SERVICE BULLETIN

Safety Recall Code 0128

2007 XL VOLTAGE REGULATOR

Figure 2. Unbolt and Remove Voltage Regulator

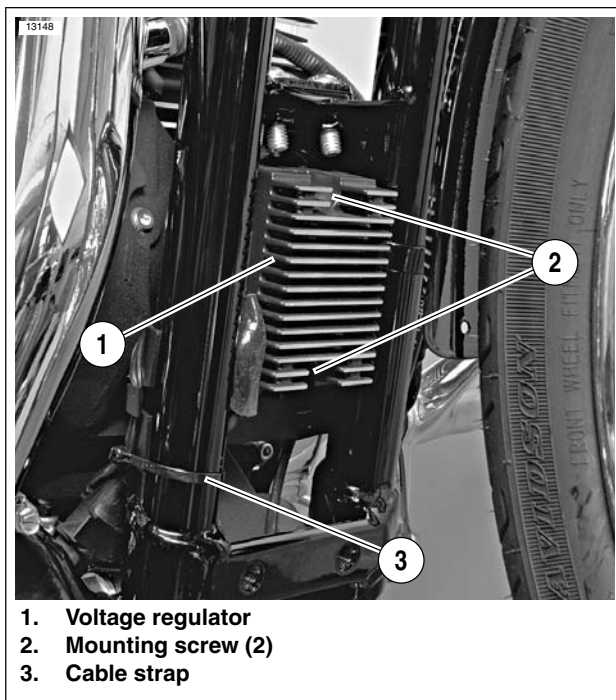
3. Remove Maxi-Fuse.
4. See [Figure 2](#). Cut cable strap (3) that secures stator harness and neutral switch wire to vehicle frame.
5. Remove two screws (2) and voltage regulator (1) from voltage regulator bracket on vehicle frame. Discard mounting screws. They will not be reused. Position voltage regulator to the side, out of the way.

Figure 3. Mount Repositioning Bracket

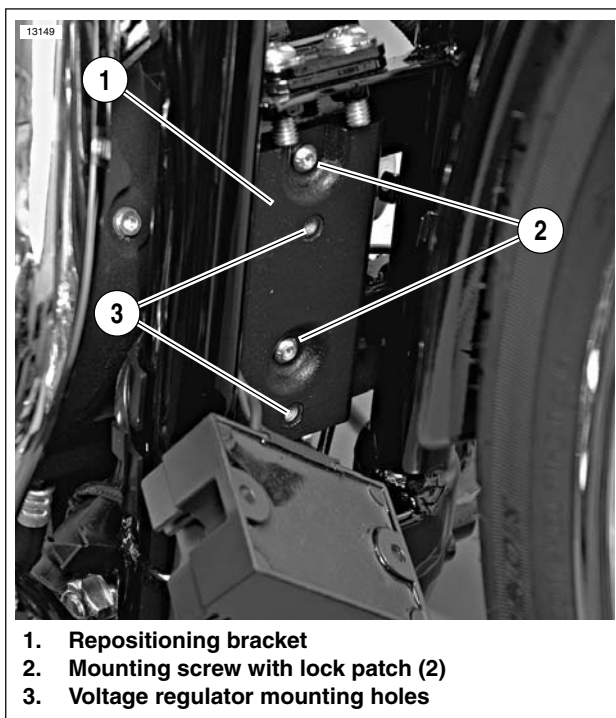
6. See [Figure 3](#). Mount repositioning bracket (1) onto original voltage regulator bracket on frame with two **new** screws (2) from recall kit. Make sure repositioning bracket is oriented as shown in the photo, so that voltage regulator mounting holes (3) are below repositioning bracket mounting holes. Tighten screws to 30-60 **in-lbs** (3.4-6.8 Nm).

Figure 4. Mount Voltage Regulator

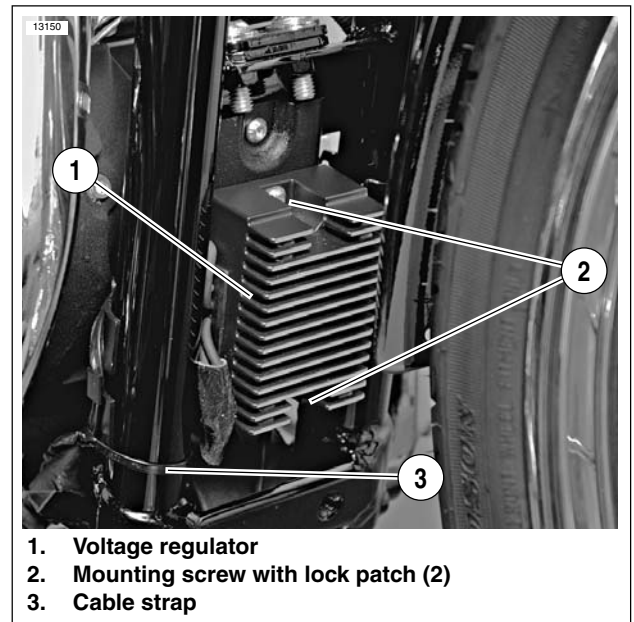
7. See [Figure 4](#). Mount voltage regulator (1) onto repositioning bracket with remaining two **new** screws (2) from recall kit. Tighten screws to 30-60 **in-lbs** (3.4-6.8 Nm).
8. Locate cable strap in recall kit. Wrap cable strap (3) around stator harness, neutral switch wire and vehicle frame. Tighten cable strap securely. Cut off excess strap material.
9. Install Maxi-Fuse.
